PL202100017

PHASE III - CONCEPT 3

U-HAUL

BLOOMINGTON, MINNESOTA - 01/27/2021
ISG PROJECT NO. 20-24791

A2-11

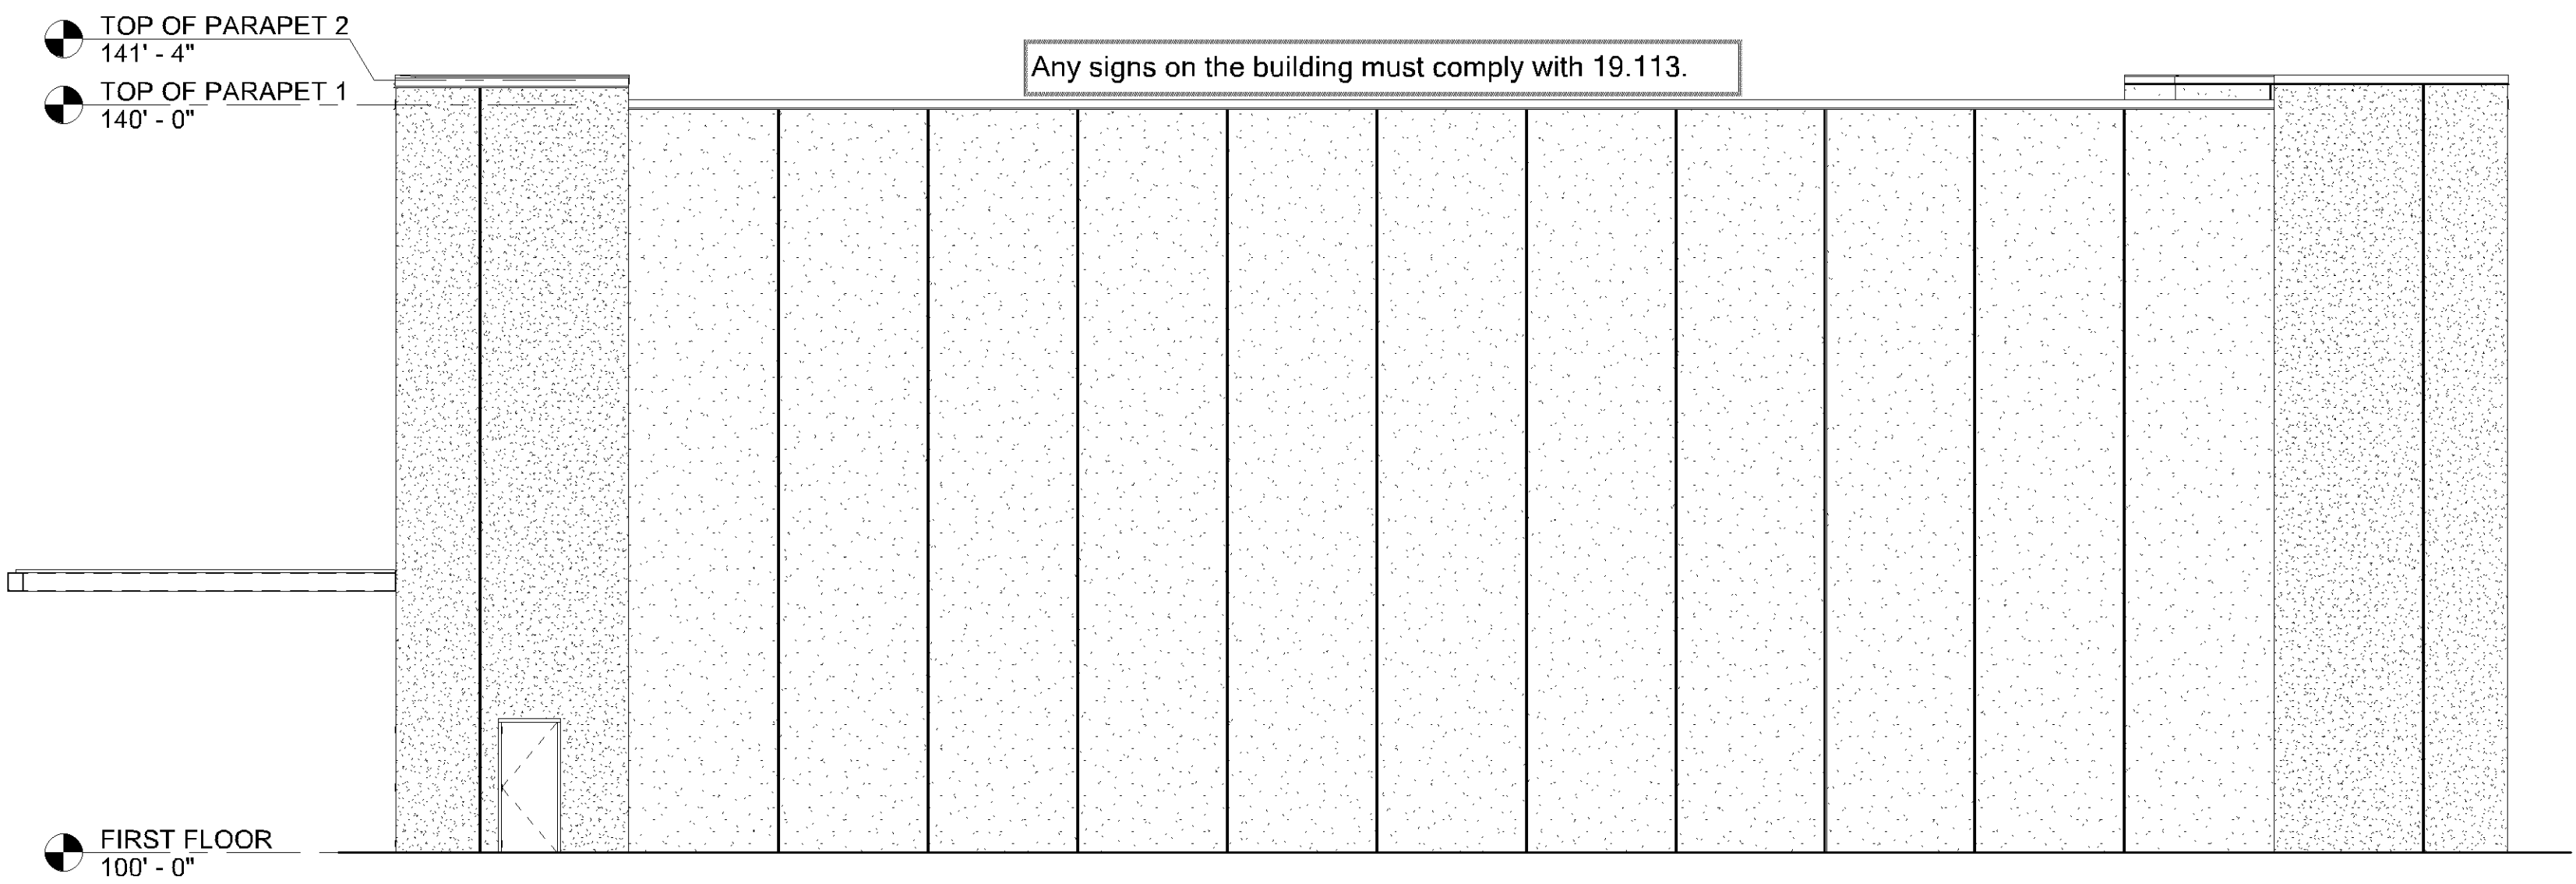
Provide windows along street frontages as opposed to the blank facade.

Any signs on the building must comply with 19.113.

Must meet 2020 MN State Building Code

Must meet 2020 MN Accessibility Code.

Provide a detailed code analysis with the plans.
